ADDENDUM NUMBER 1
ATLANTA ST AT SOUTH MARIETTA PKWY
INTERSECTION IMPROVEMENTS
PROJECT NUMBER 12081
PI NUMBER 0012606
Issue date: August 18, 2016

Answers to Questions submitted:

STATE OF GEORGIA
 DEPARTMENT OF TRANSPORTATION
 OFFICE: **MAINLINE PLAN**
 ATLANTA ST AT S MARIETTA PKWY
 ST INTERSECTION IMPROVEMENTS
 DRAWING NO. **13-001**

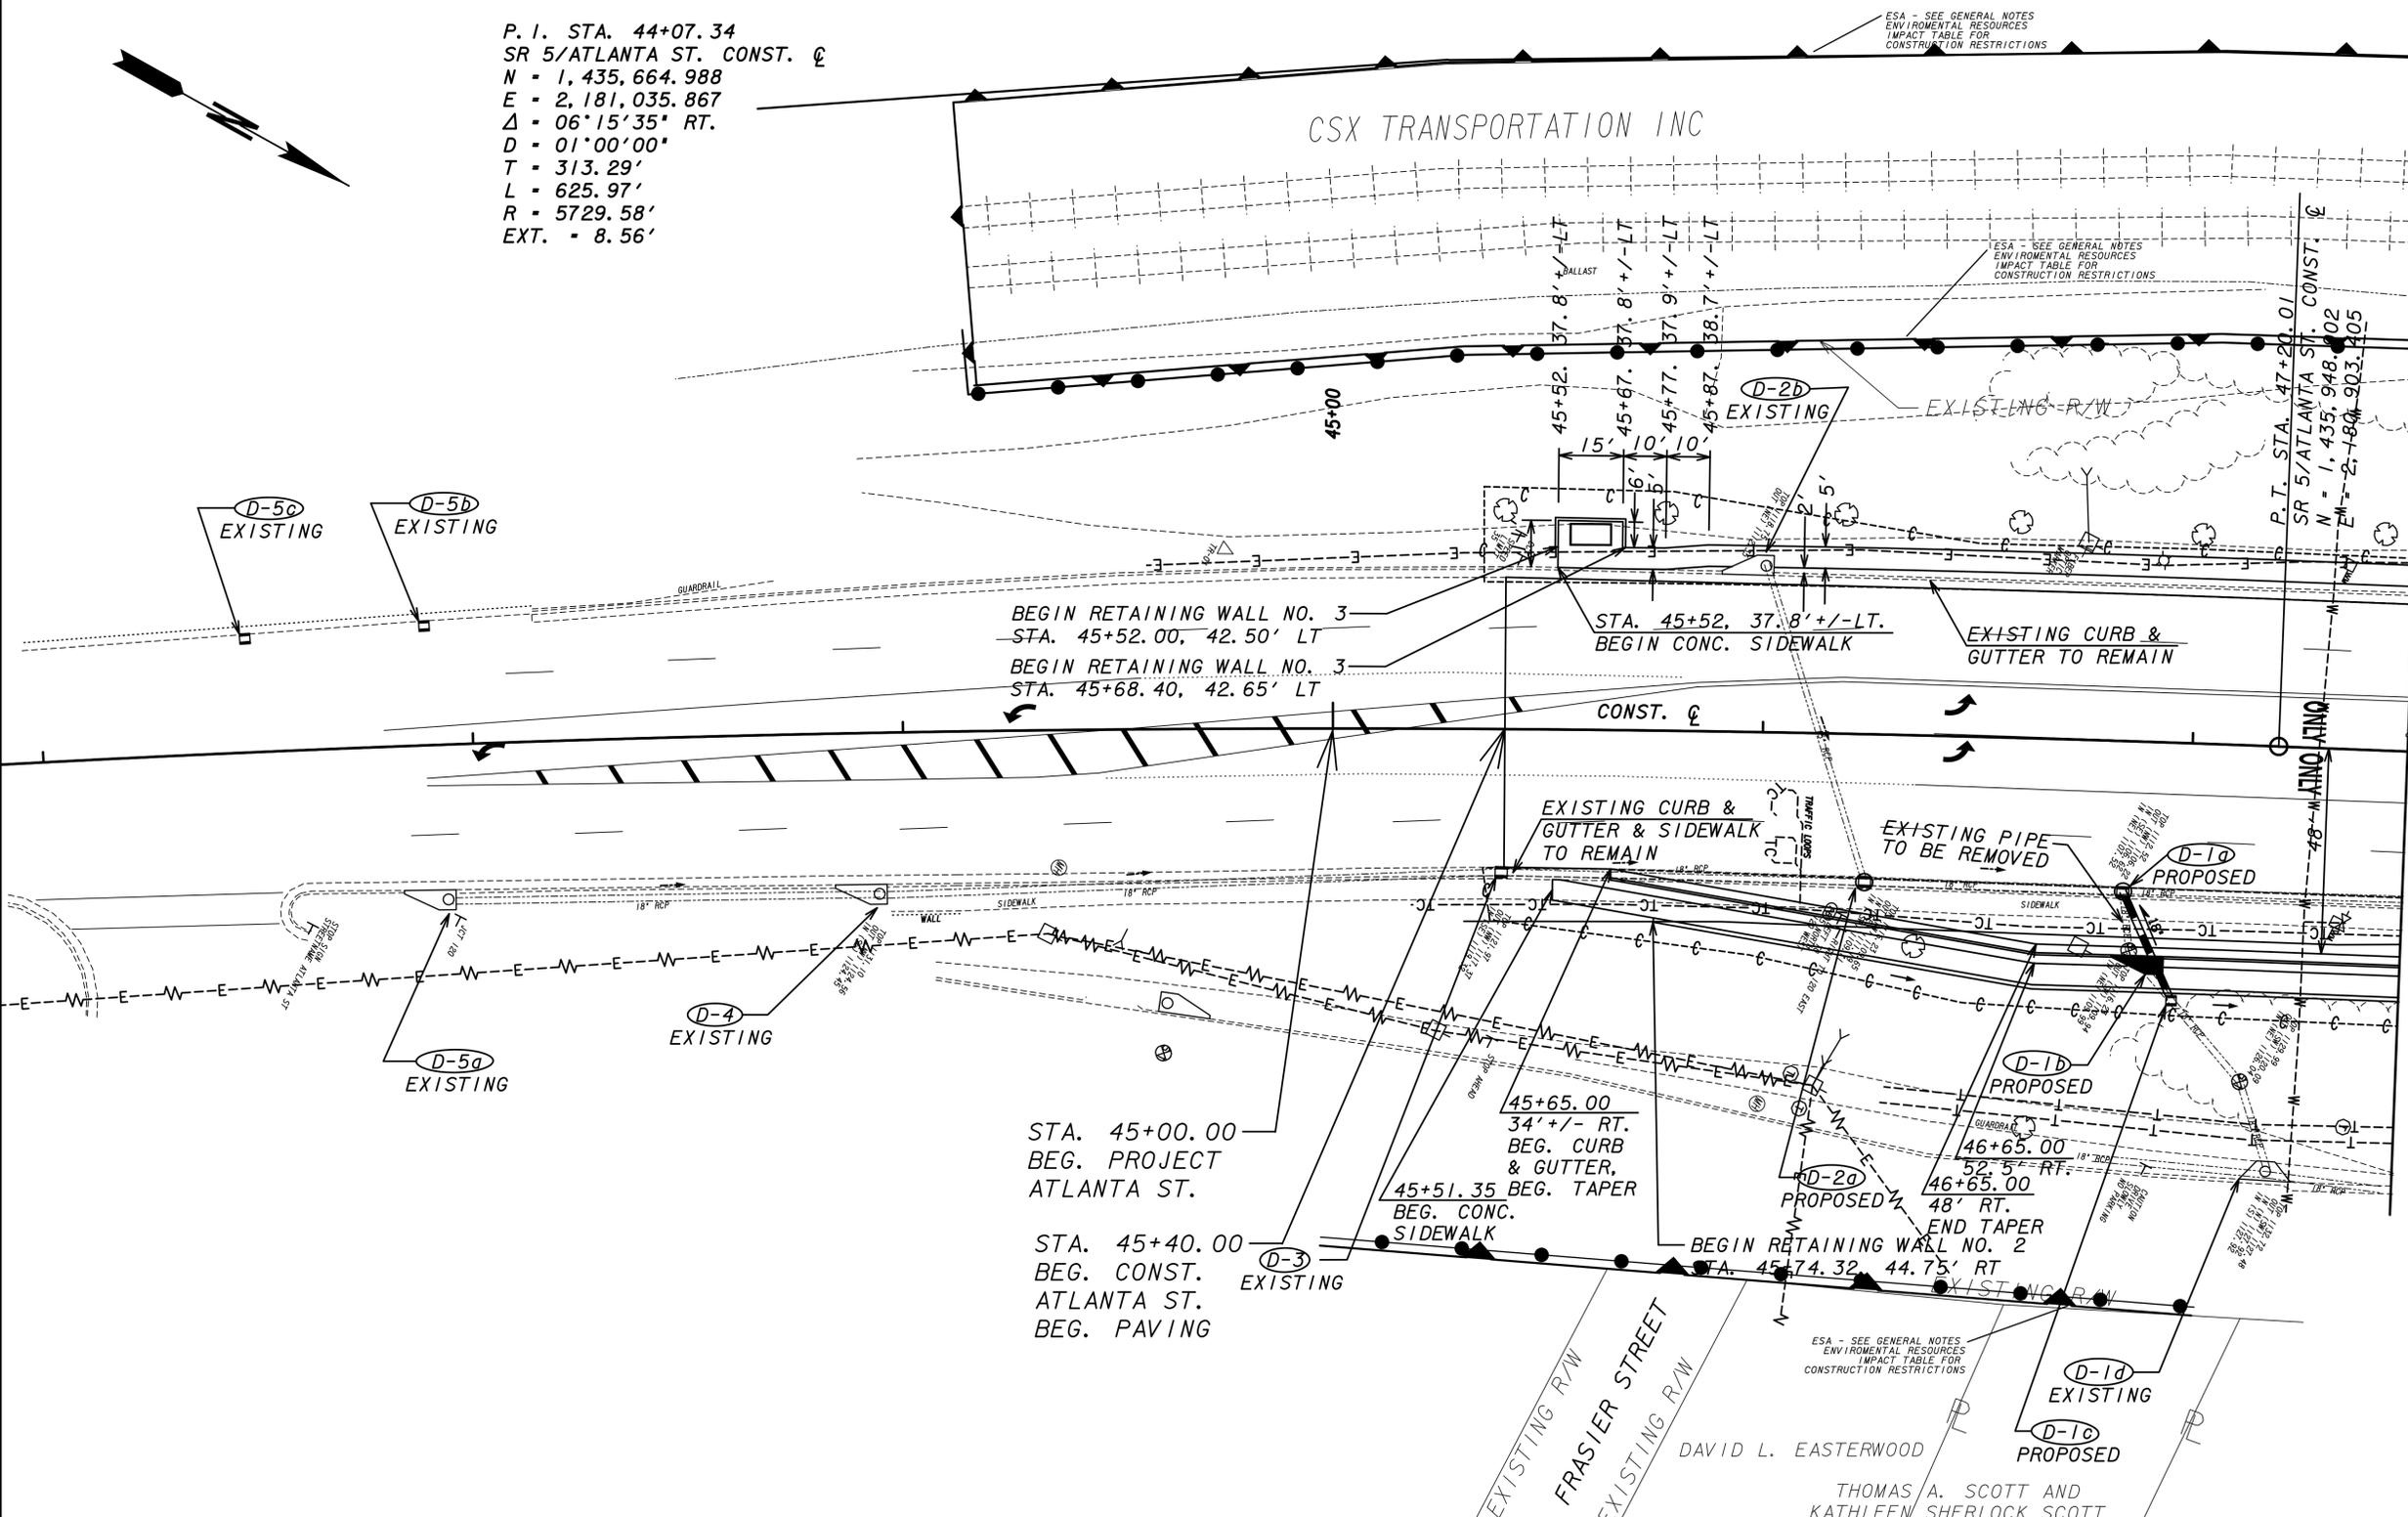
40. There is not a profile for gravity wall 3. Will a profile be given for wall 3?

NO, REFERENCE GEORGIA STANDARD DETAIL 9031L.

TYPICAL SECTION NO. 10
SUPERELEVATED SECTION
 APPLICABLE TO SR 120/SOUTH MARIETTA PKWY.
 FROM STA. 32+07.93 TO . STA. 33+50.00

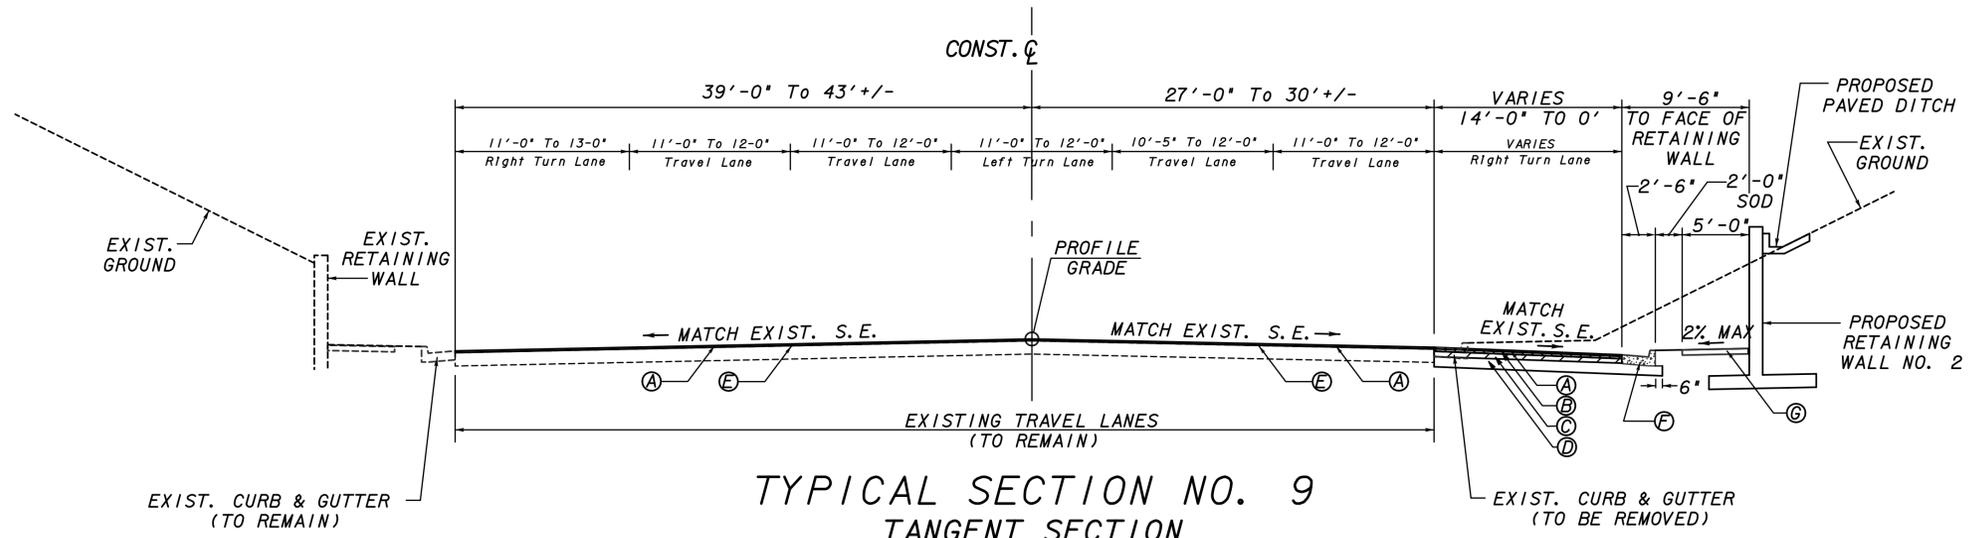
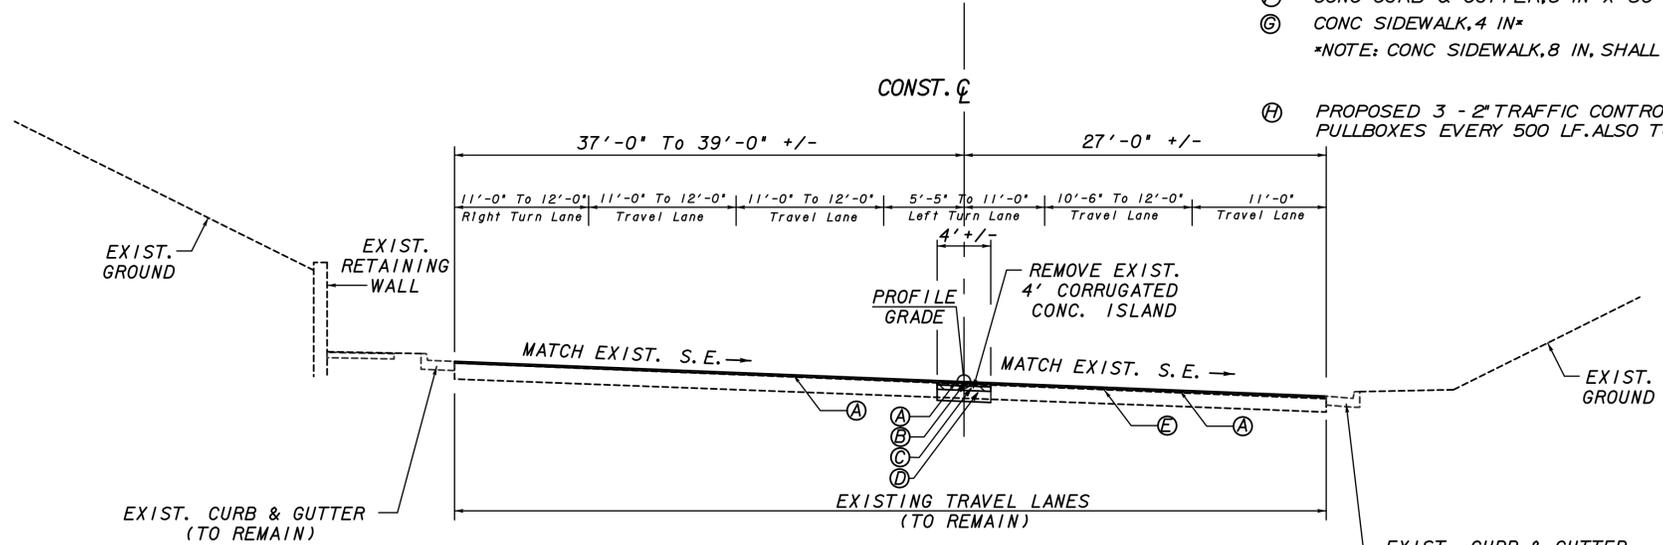
6. Typical section #10 shows the existing 4' corrugated concrete island being replaced with 8x30" Type 2 C&G and then overlaid with 12.5mm asphalt. We believe the wrong legend was applied in this section as it should be either full depth or class B concrete. Would the City please review this typical section?

THIS HAS BEEN CORRECTED, CURB AND GUTTER HAS BEEN REMOVED AND QUANTITIES FOR PAVING HAVE BEEN ADDED.
